**VEHICLE SAFETY DEFECT SERVICE BULLETIN**  
**Recall Campaign No. 06V429000**  
**Monaco File # R06036**

**Re: Safety Recall – Missing Heat Shield**

**RECALL 06V429000**  
**CANADA # 06-282**  
**LP TANK HEAT SHIELD INSTALLATION**

Before

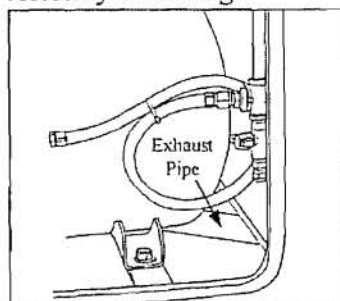
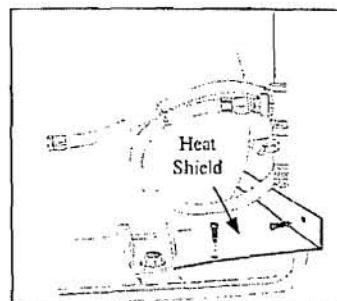
Monaco Coach Corporation has become aware of a safety defect with respect to the LP tank and the HydroHot exhaust. Monaco has determined that during this period of time, our manufacturing plant 17 in Coburg, Oregon was not installing heat shields in the LP tank bay even though the exhaust for the HydroHot is within 18" of the LP tank. This is located under the coach, near the LP tank on the passenger side. This is a violation of ANSI A119.2 code 5.2.5. The heat from the HydroHot exhaust could place excessive temperature on the exterior of the LP tank and result in unexpected venting of LP gas through the LP tank safety relief valve. LP gas leakage in the presence of an ignition source could result in a fire. As a precautionary measure, Monaco Coach Corporation has elected to perform this voluntary safety recall campaign.

Install a heat shield between the LP tank and the Hydro Hot exhaust pipe to resolve a code violation.

1. Locate LP tank storage bay in front of the passenger side rear tire.
2. Insert supplied heat shield into bay between LP tank mounting feet and bay structure and the front wall of the bay.
3. Secure the heat shield to the outer lip of the LP tank bay surround and the front wall of the bay with 1" X 3/8" self tapping screws supplied.
4. Using black silicone caulking run a bead around the perimeter of the heat shield on the underside to reduce the possibility of rattling.
